TENANT IMPROVEMENT PLAN CHECK COMMENTS

PLAN CHECK NO:	10174363		
PROJECT ADDRESS:	4 E Hutton Center Dr Unit# 370		
PLAN CHECK ENGINEER:	Mazarji, Zac	TEL: 714	647-5831
		FAX: 714	647-5897
TYPE OF CONSTRUCTION:	I A, SPK		
OCCUPANCY CLASSIFICATION(S):	B		
PLAN CHECK DATES:		REMARKS/RECHECK ITEMS:	
APPLICATION	2/9/2012	_____	
INITIAL REVIEW	2/10/2012	_____	
EXPIRATION	8/7/2012	_____	
RECHECKS:	1.	PROJECT APPLICANT CONTACT PERSON:	
	2.	Fraser McClellan	
	3.	TEL:	(714)307-6883
		FAX:	(714)897-5952
VALUATION:	\$117,800.00	EMAIL:	Fraser@fmacorp.com
FLOOD ZONE:	X-0602320278J

TENANT IMPROVEMENT PLAN CHECK COMMENTS

Tenant Improvements for:
HFS CONSULTING
 Suite Expansion & Remodel
 Suite 370

COVER SHEET

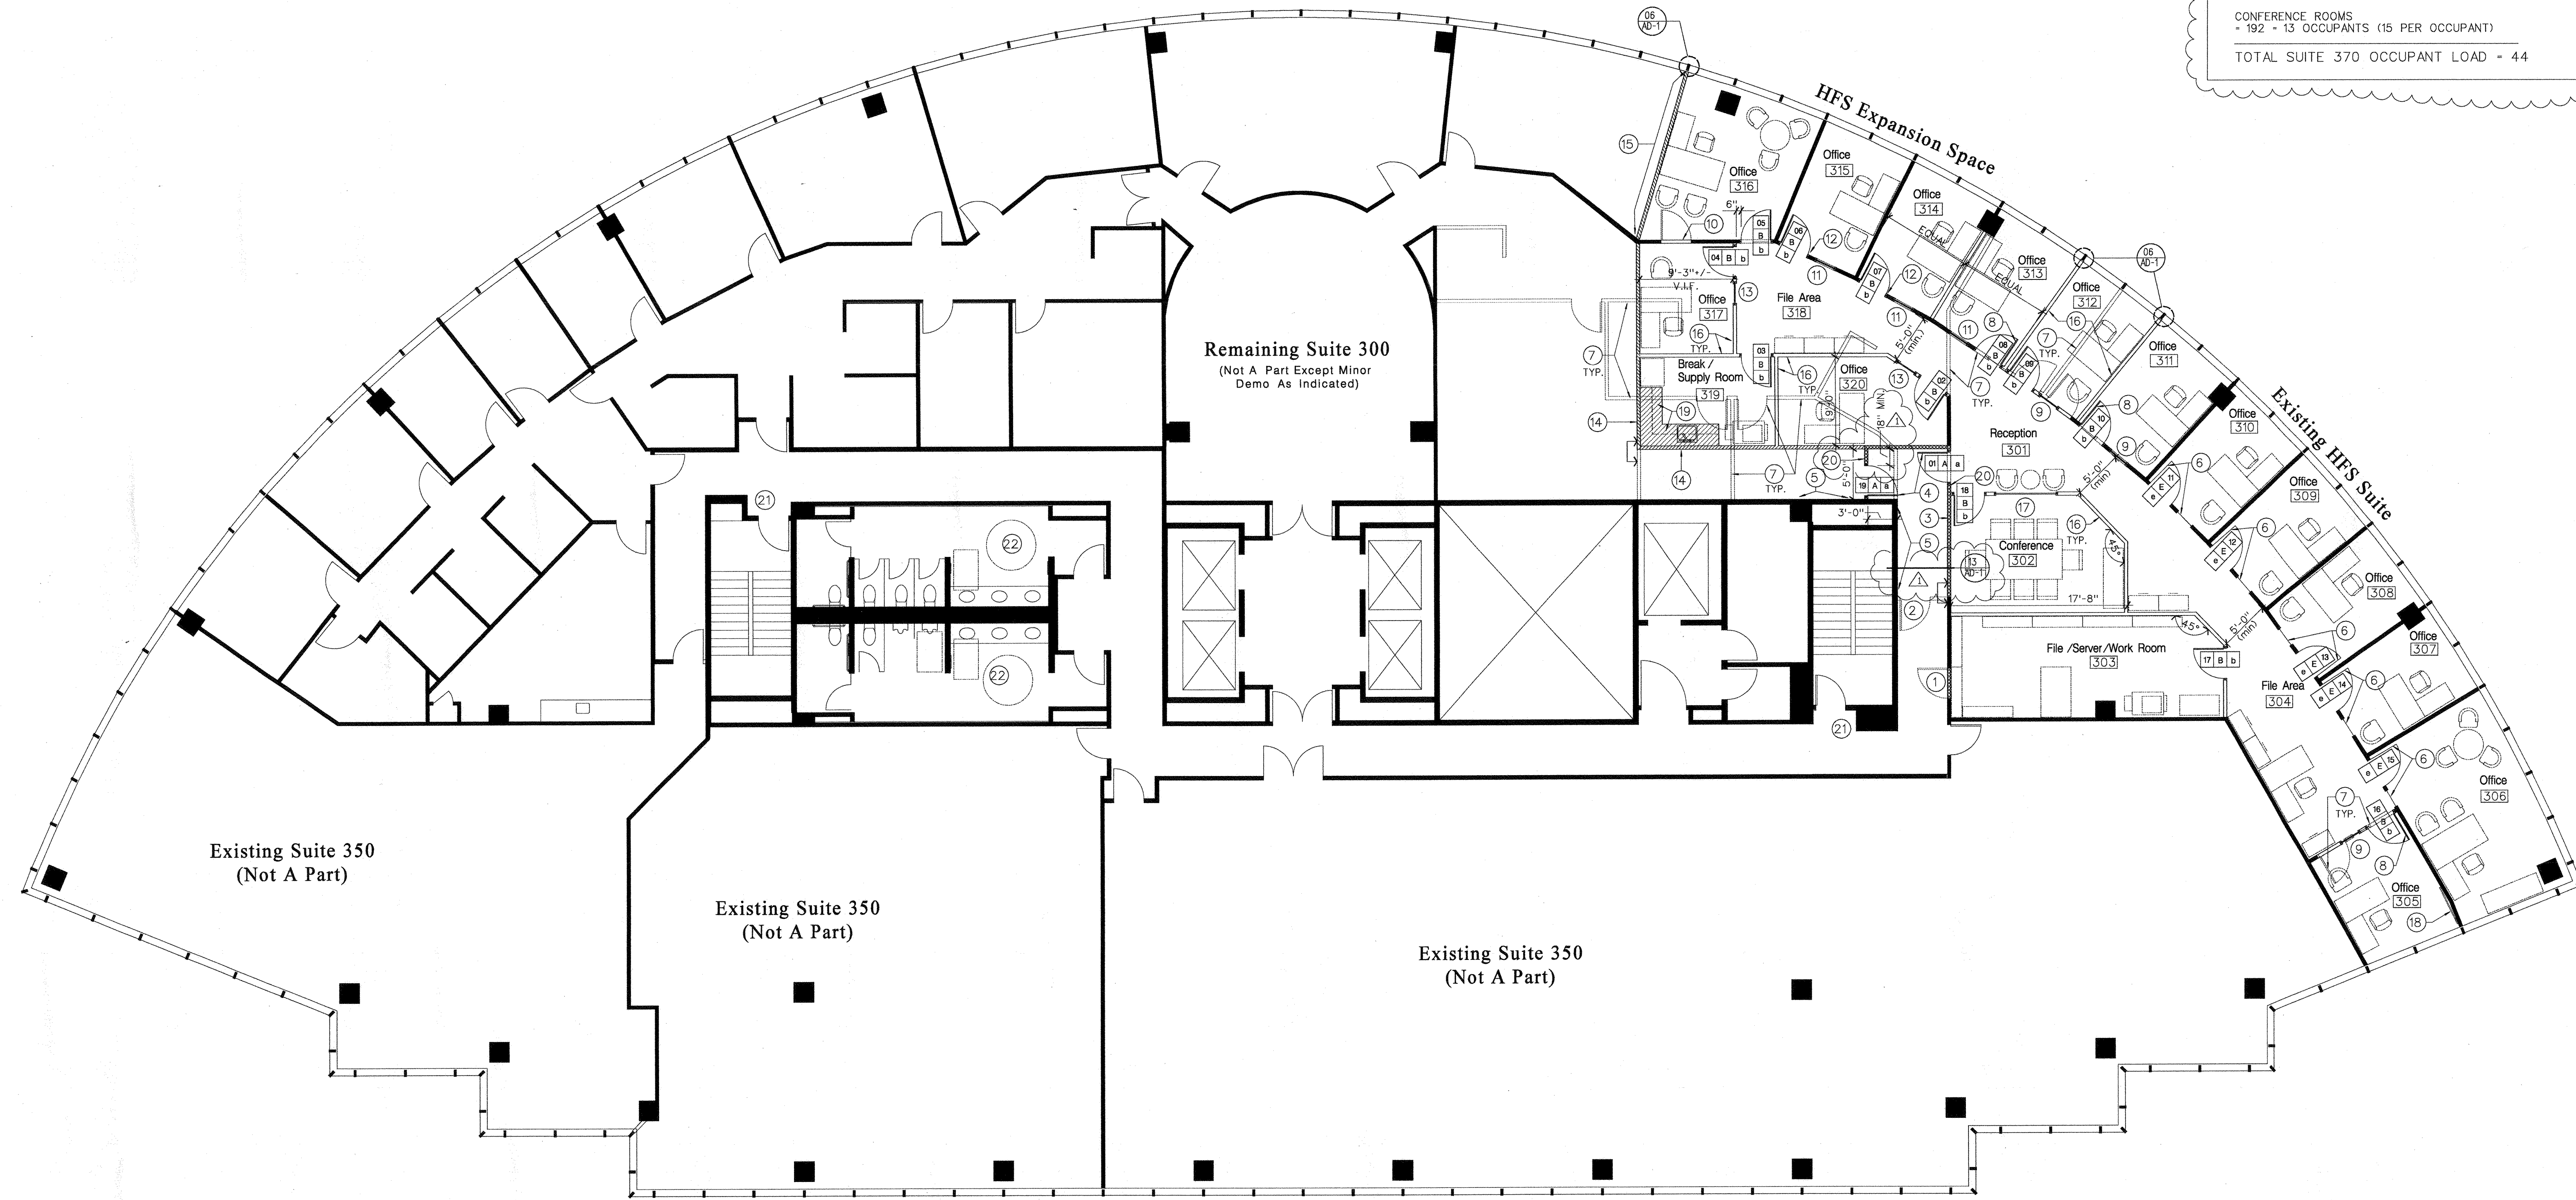
8. Provide on the drawings interior wall and ceiling finish schedule showing compliance with CBC Section 803 and CBC Table 803.5. *REQUIRED NOTE IS ON COVER SHEET*

15. Exit illumination and exit sign requirements in accordance with CBC Section 1011 shall be shown on the drawings.. *NOTE 20 "BUILDING DEPARTMENT NOTE" ON COVER SHEET*

16. CBC Section 1006, Requires means of egress from all occupied parts of the building be provided with at least 1' candle of light at floor level. Show compliance on the drawings. *BUILDING DEPARTMENT NOTE 24 ADDED ON COVER SHEET*

27. Show/note ventilation requirements on the plans in accordance with the CBC and California Mechanical Code (CMC) requirements for each type of use. *NOTE 22 MODIFIED ON COVER SHEET*

28. Show/note LIGHTING requirements on the plans in accordance with CBC and California Electrical Code requirements for each type of use. *BUILDING DEPARTMENT NOTE 25 ADDED TO COVER SHEET*

CONSTRUCTION PLAN

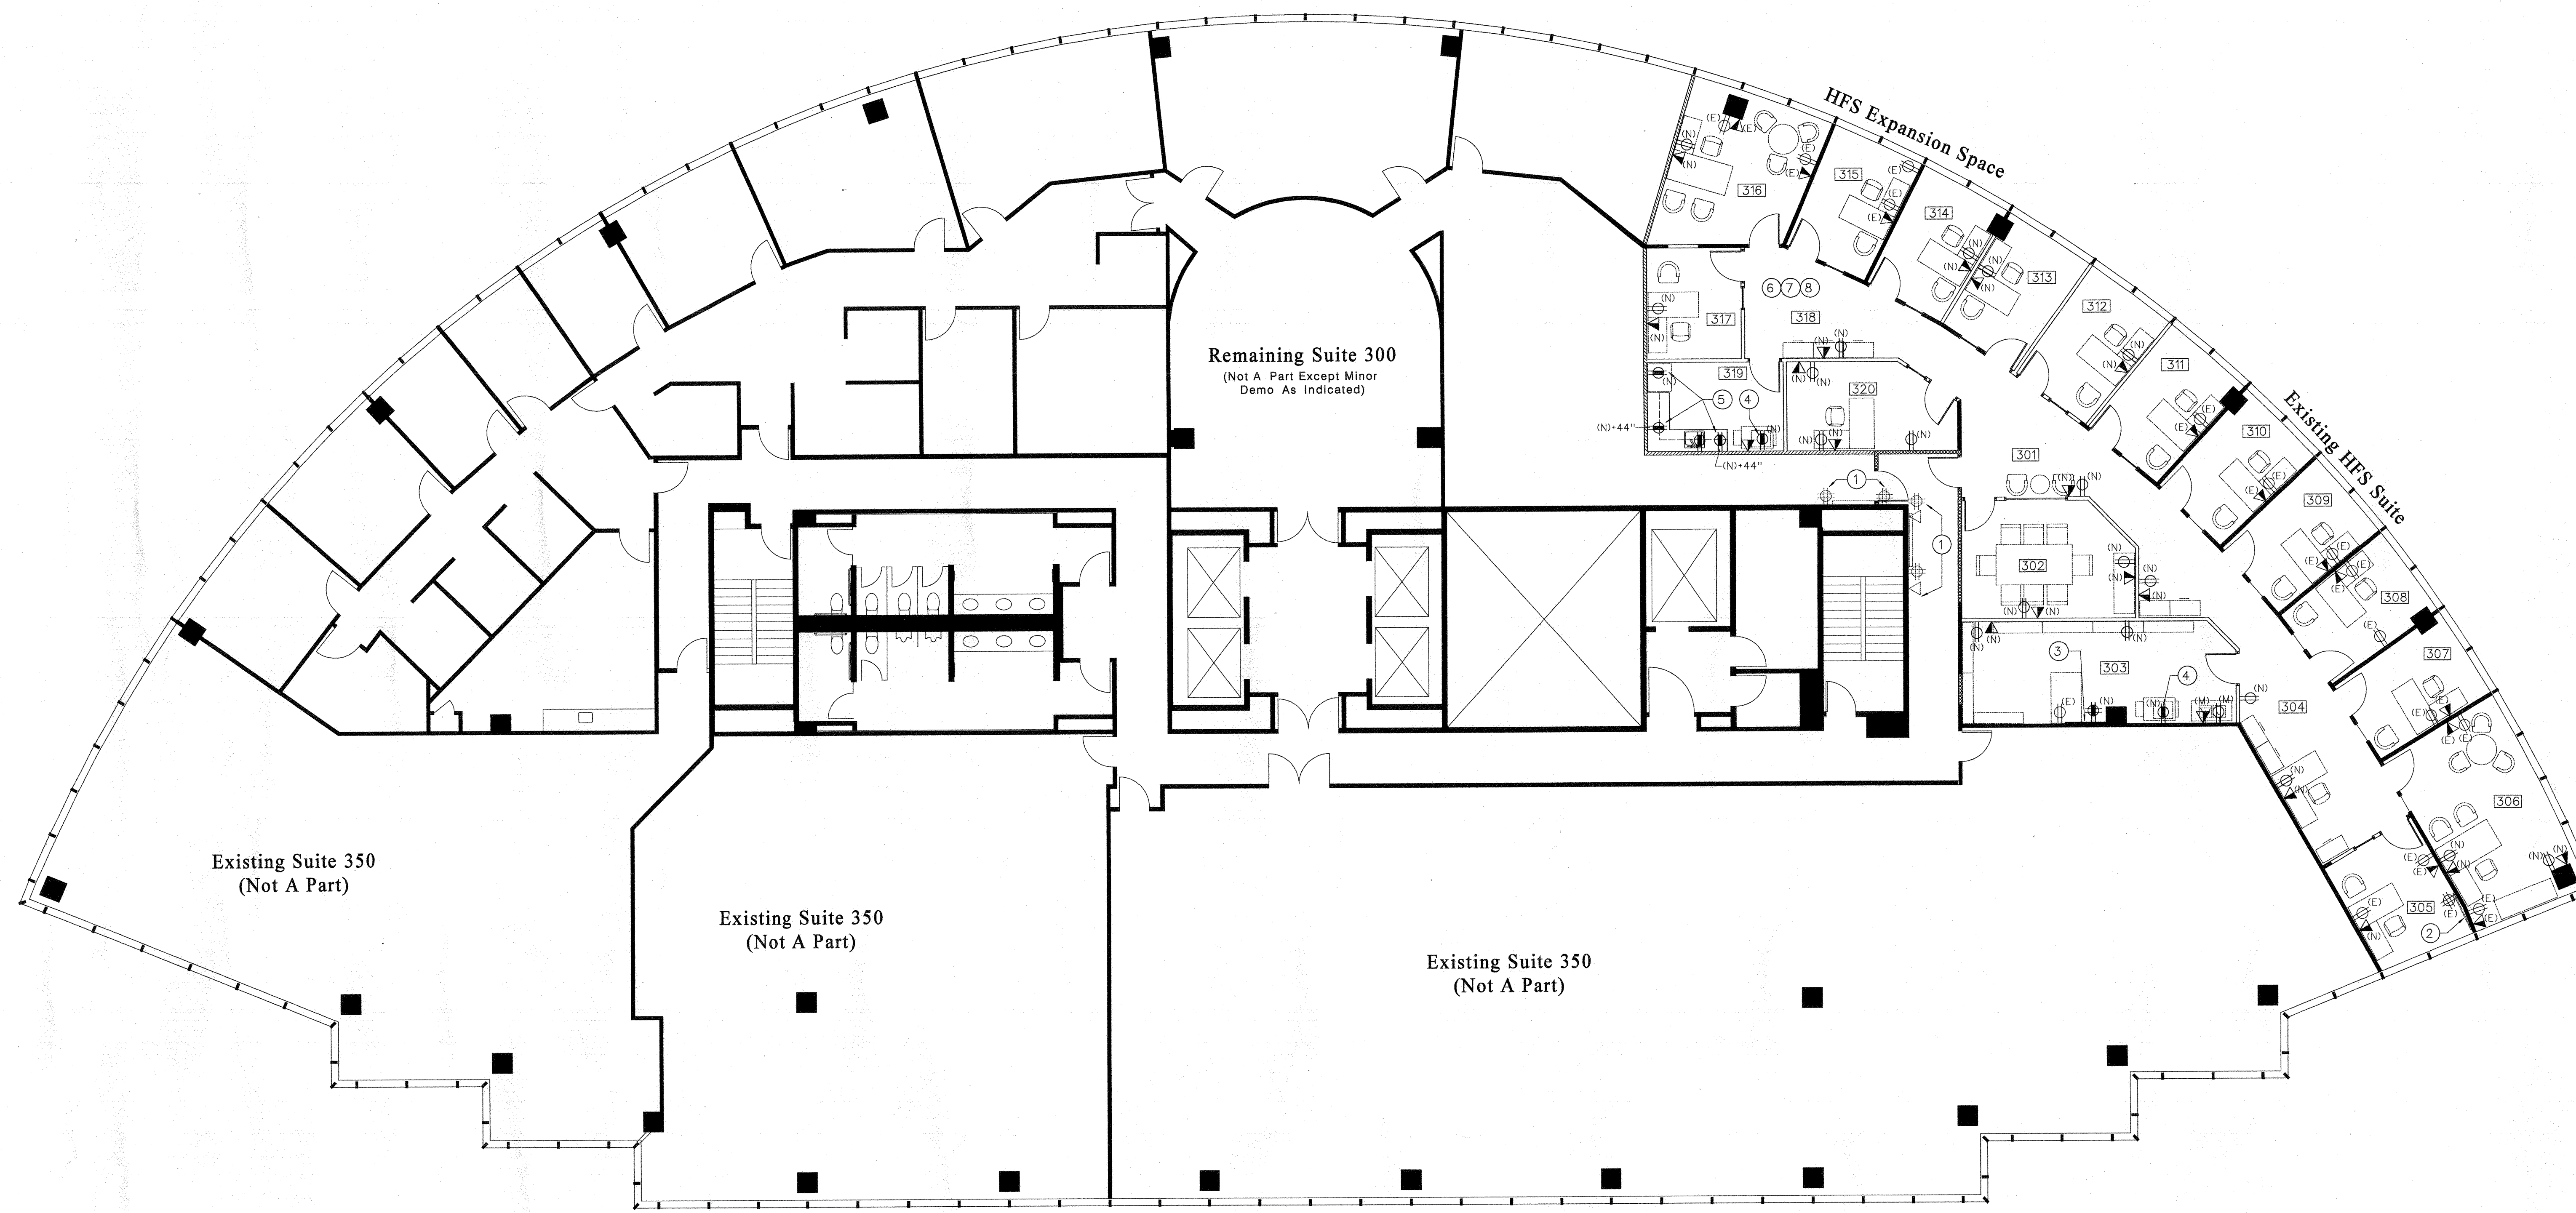
9. Note on the floor plan the use and occupancy load of each room and/or area. Relate each use to a CBC Table item. Note occupant loads which are the greater number based on CBC Section 1004 and Table 1004.1.1 or the actual number of occupants.

REFER TO NEW OCCUPANT LOAD TABLE ON SHEET A-1

BASE CABINET SECTION SCALE: 1"=1'-0" 16

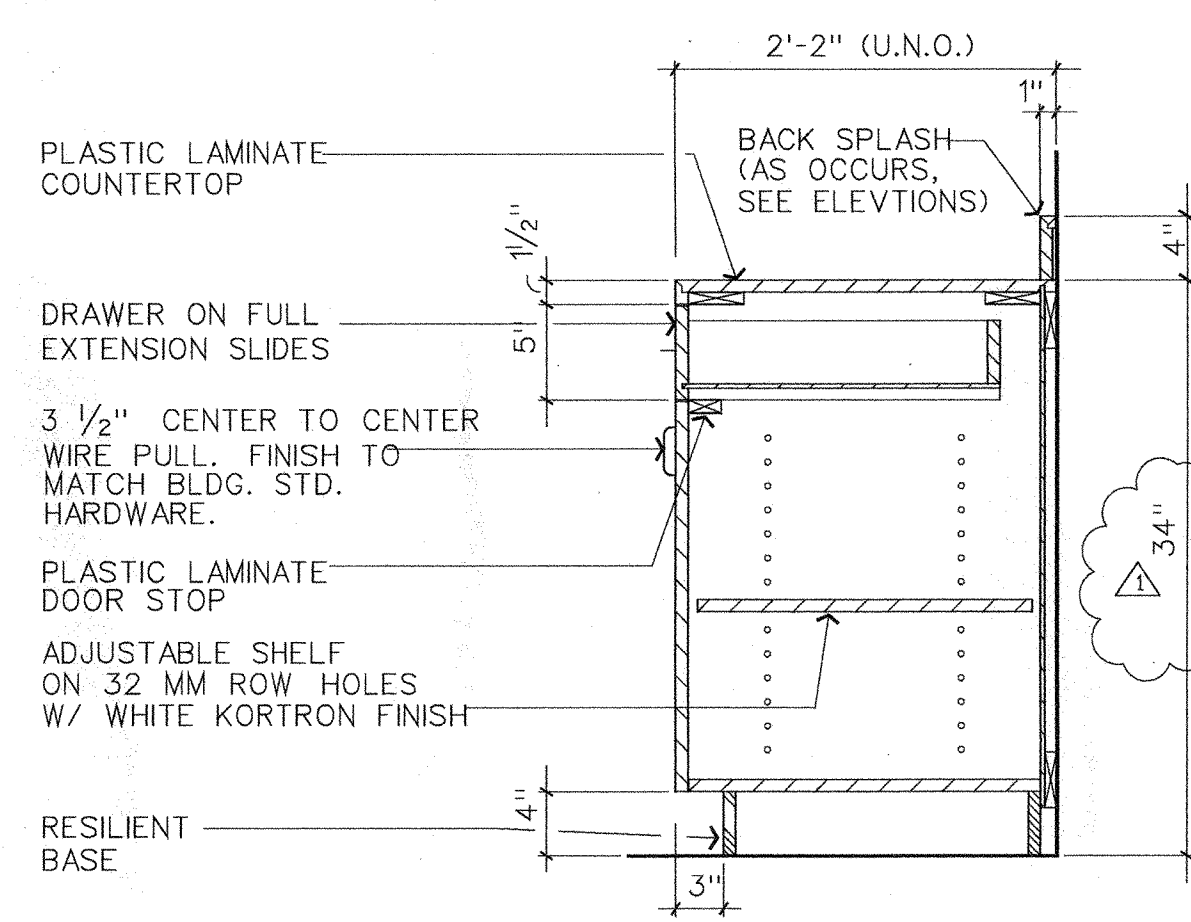
21. Reference sheet AD-1 detail # 16; indicate maximum height of 34" for base cabinets. *CHANGED TO SHOW 34"*

FIRE RATED CORRIDOR SCALE: 1/2"=1'-0" 13

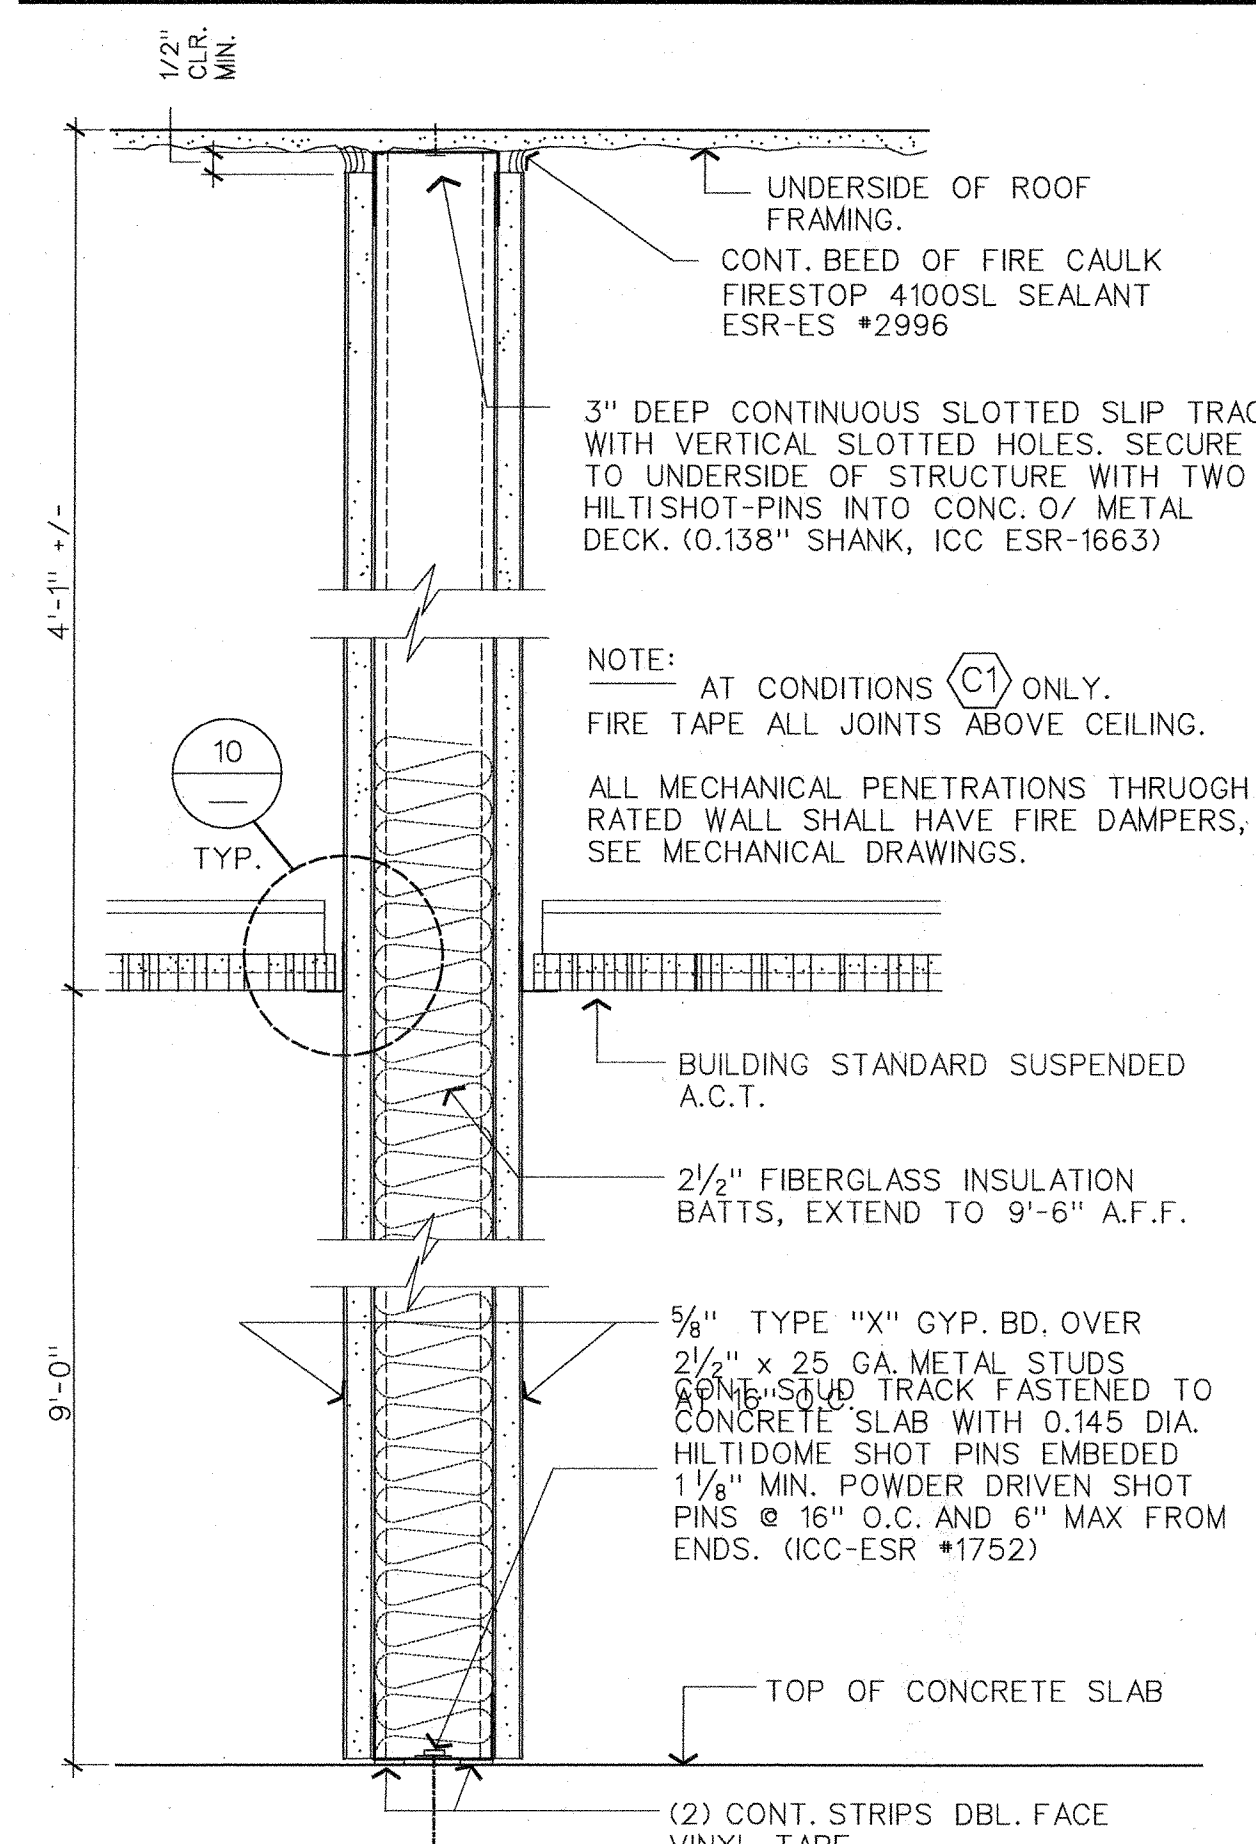
20. Please provide cross reference from modified fire rated corridor to detail # 13 on sheet AD-1. *DETAIL REF. ADDED ON A-1*
